Called Design Review Committee Meeting

DEPARTMENT OF PLANNING AND ZONING PLANNER'S REPORT

DATE: July 24, 2019
TO: Tonya Hutson
FROM: Michael Smith
VIA: Lynn Patterson
RE: **Design Inspection – 491 Walnut Street –**

DATE: June 29, 2019
TO: Tonya Hutson
FROM: Michael Smith
VIA: Lynn Patterson
RE: **Design Review – 3093 Hope Street Remodel**

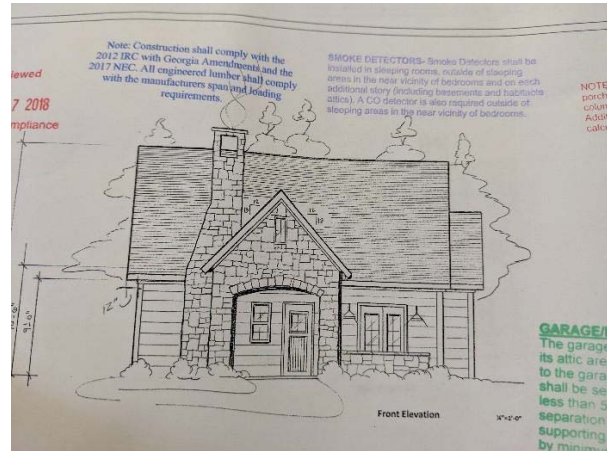
8. A gable vent shown on the plans is absent.

9. The front door is a different style than what is in the approved designs.

10. The house is now raised, and steps have been added to the porch.

The window shown in the plans was not needed as originally designed and would have been a “fake” gable window. Our decision was to remove from the plans to better compliment the Tudor style of the home and overall curb appeal for the neighborhood. We would like for the committee to vote that we are allowed to keep this as constructed. (Revised plans and picture provided)

Correct, after meeting with the door/lumber company and laying everything out, we felt this door added beautiful architectural design that goes with the Tudor style of this home. This door cost triple the price of a standard door and again, we’ve received nothing but compliments from the neighbors and contractors. We would like the committee to vote that we are allowed to keep this door as it is. (Revised plan and picture)

Correct, this keeps us above the flood level and adds a beautiful front elevation, our neighbor at 493 also made this decision with their new home. With 493 being elevated we would have set far below them and would have faced a major run off problem if not elevated. We would like the committee to vote that we are allowed to keep this as it is. (Revised plan and picture provided)

Front façade (taken 7/23; updated with walkway, landscaping, light and street numbers at door)

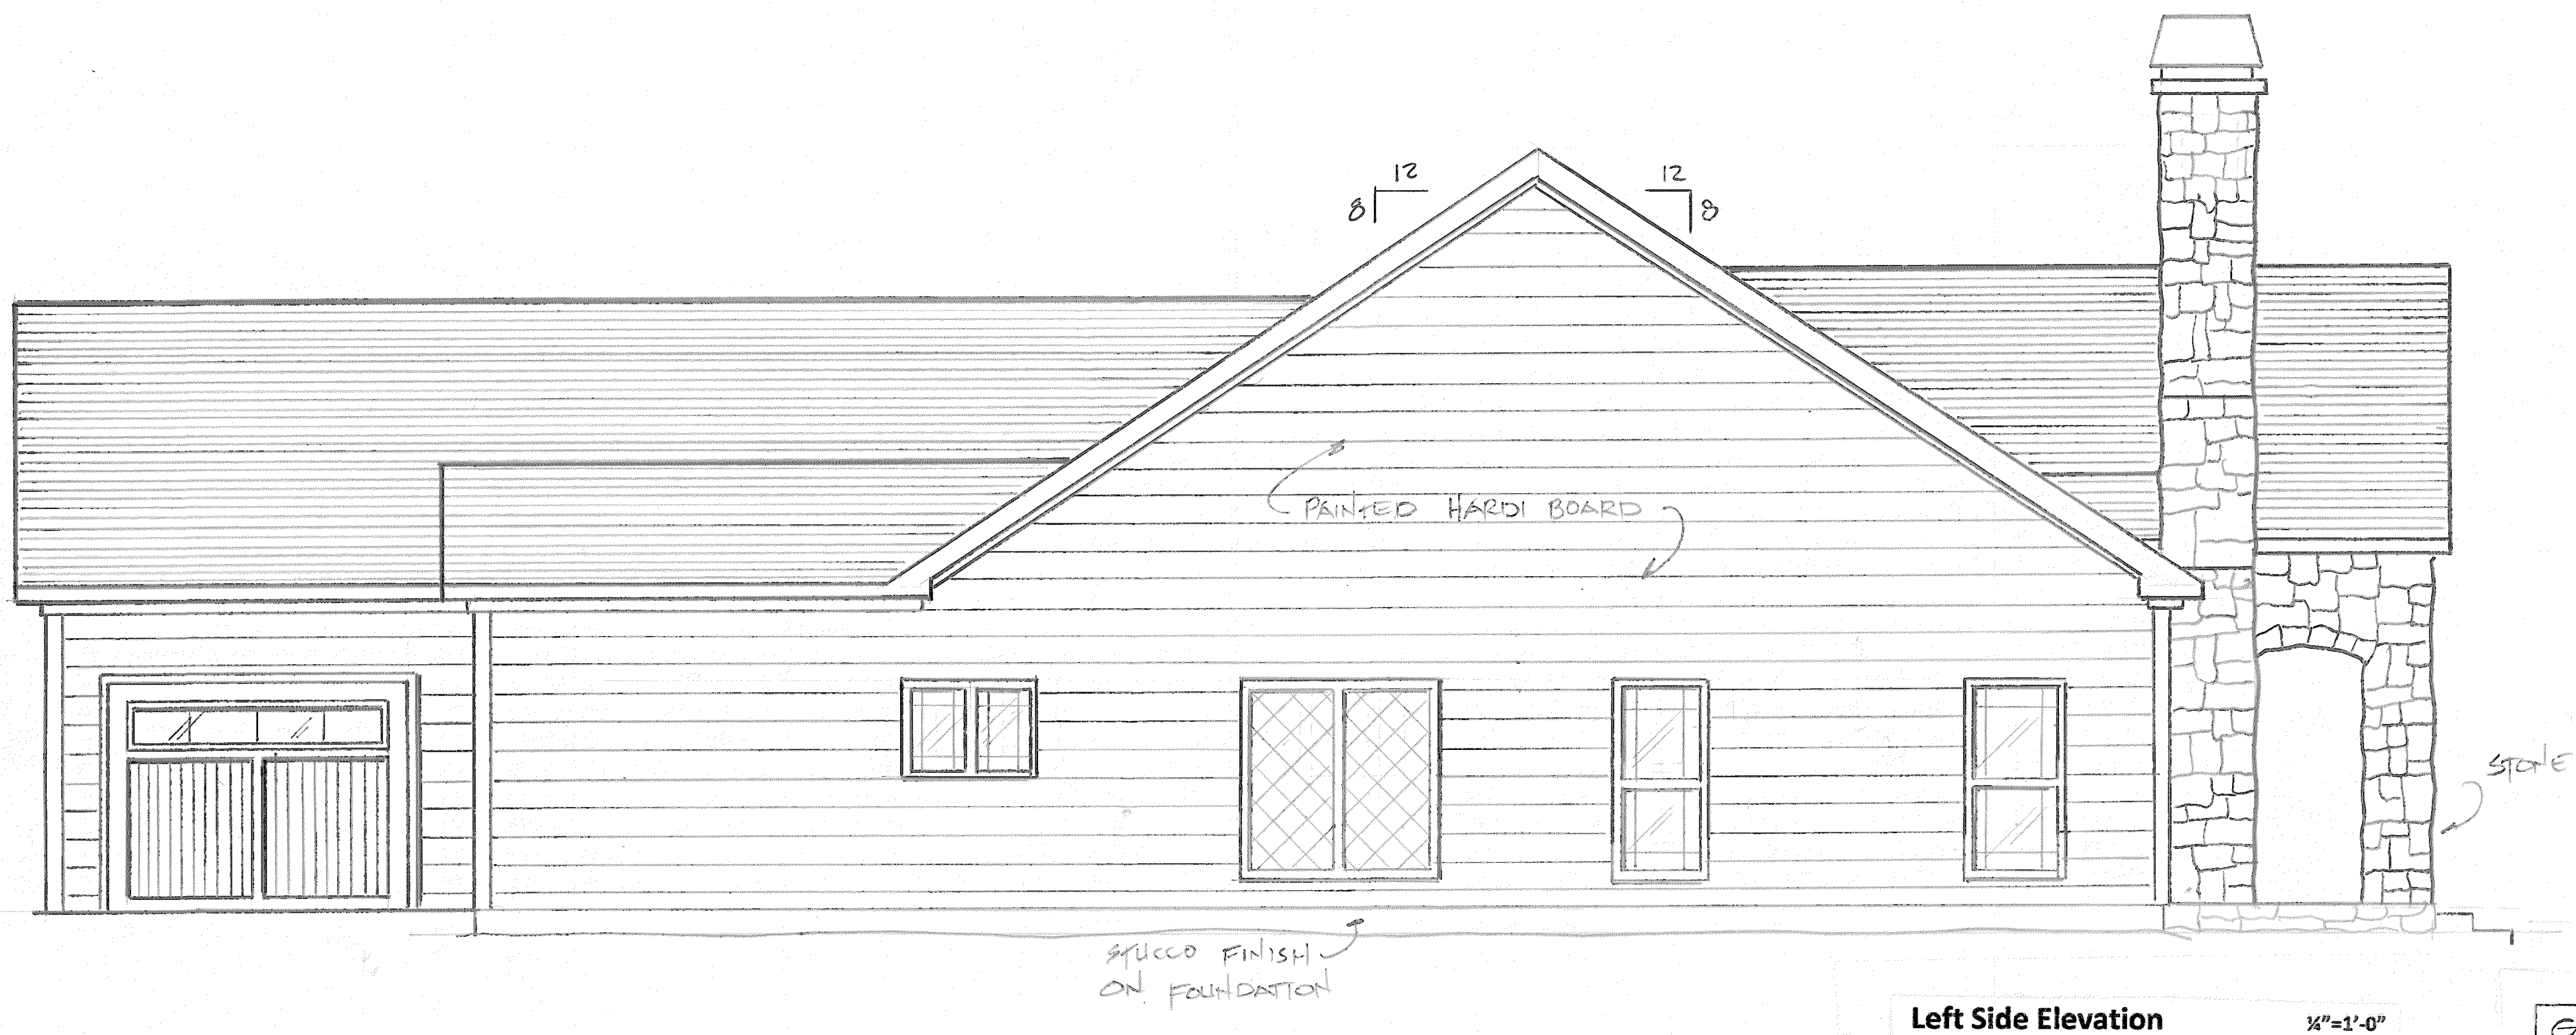
Front Elevation-
Revised Chimney Cap
Revised Front Door
Revised grid patterns in window and window height
Added Stone to front wall under porch
Added step
Added height to porch stone wall
Removed vent from gable
Revised the style of the bedroom door exterior lights

Left Side Elevation-
Revised grid patterns in windows and window heights
Revised Dining Room windows from triple unit to double unit
Added finishes notes
Raised slab foundation
Revised Chimney Cap

The final design of the house as constructed deviates from the approved designs and is not compliant with the Architectural Design Standards. The applicant will need to submit revised plans to the City and present the plans for approval to the Design Review Committee.

A.2

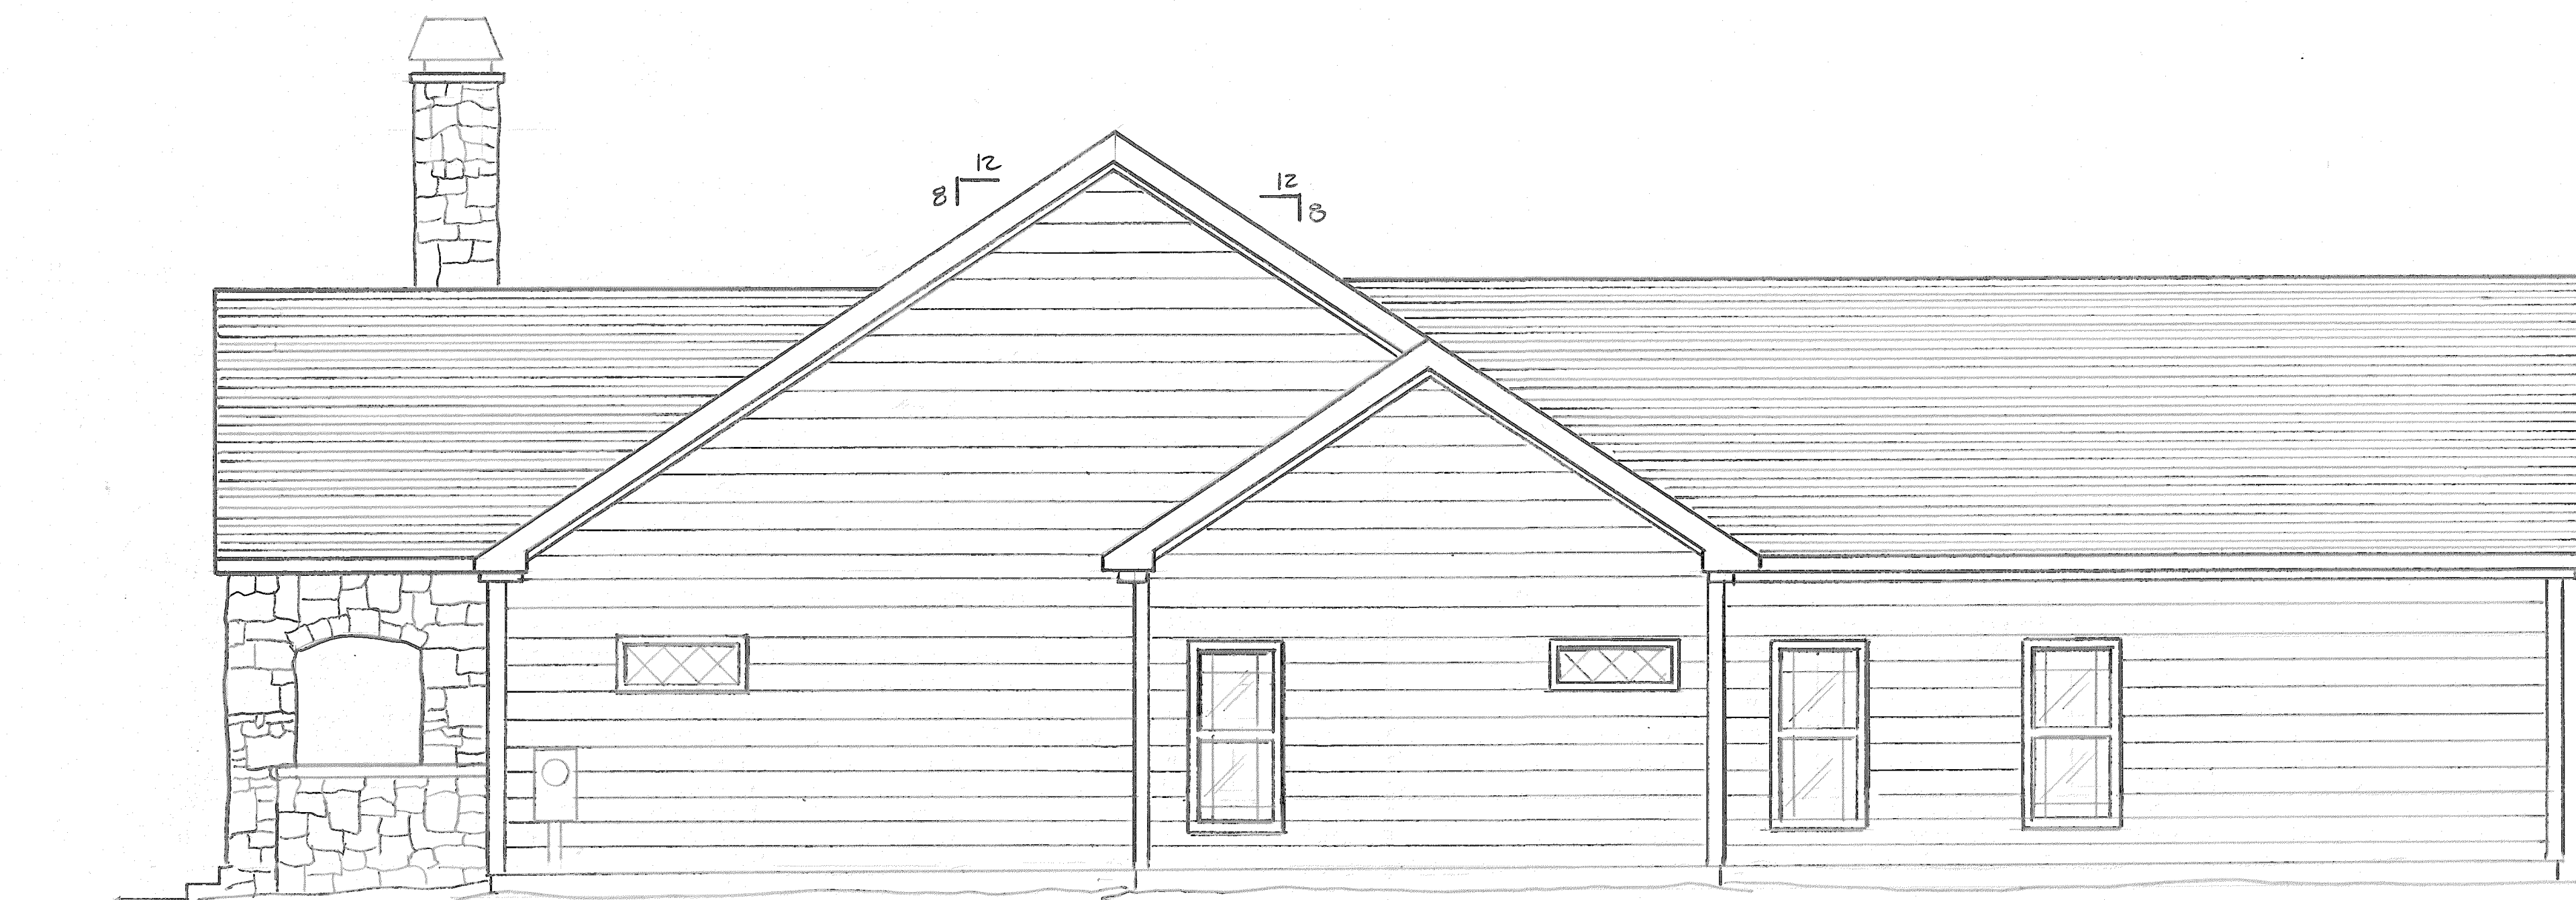
Right Side Elevation-
 Revised Chimney Cap
 Raised Height of front porch wall
 Added transom window to the front bedroom
 Revised grid patterns in windows and window heights
 Raised concrete slab foundation

Rear Elevation-
 Added garage walk thru door
 Revised grid in windows and window height
 Revised chimney
 Raised concrete slab foundation

A.4

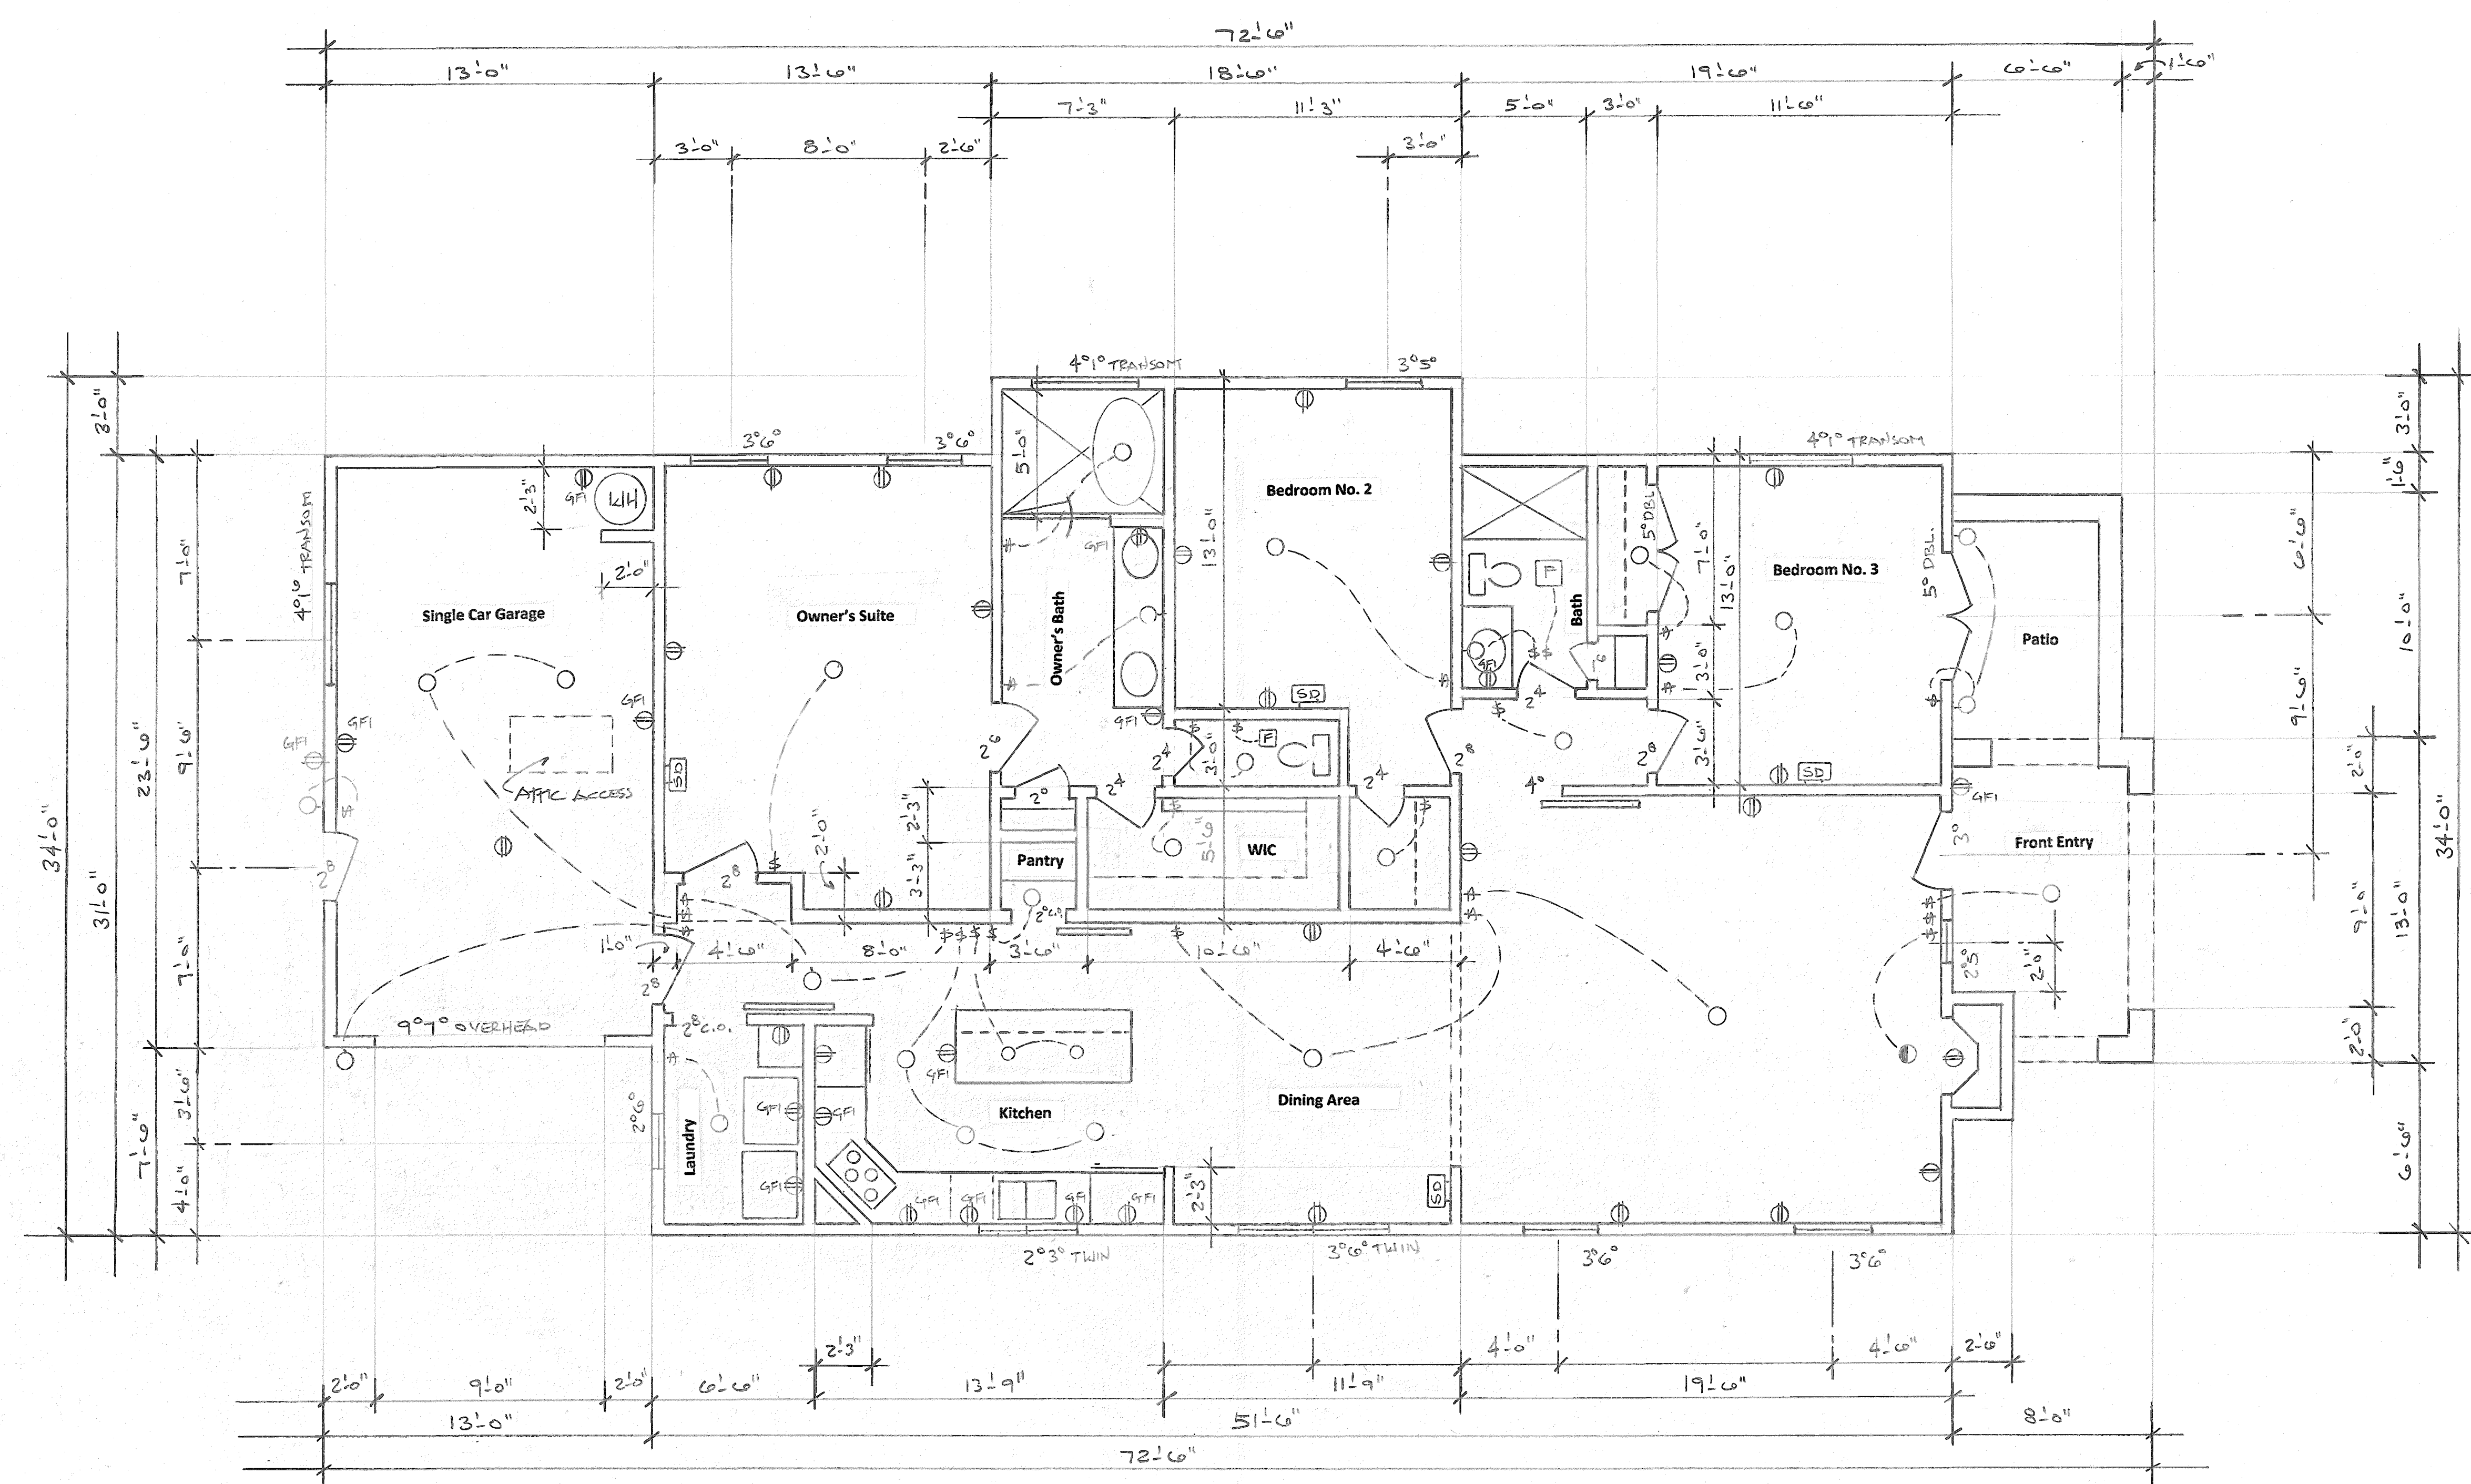
July 22, 2019 Revisions to Sheet A.4
Added garage walk thru door
Added light fixture at new door
Revised dining room window from triple to double window unit
Added transom window in the front bedroom side wall
Revised all 5'0" high window dimensions to 6'0" window dimensions
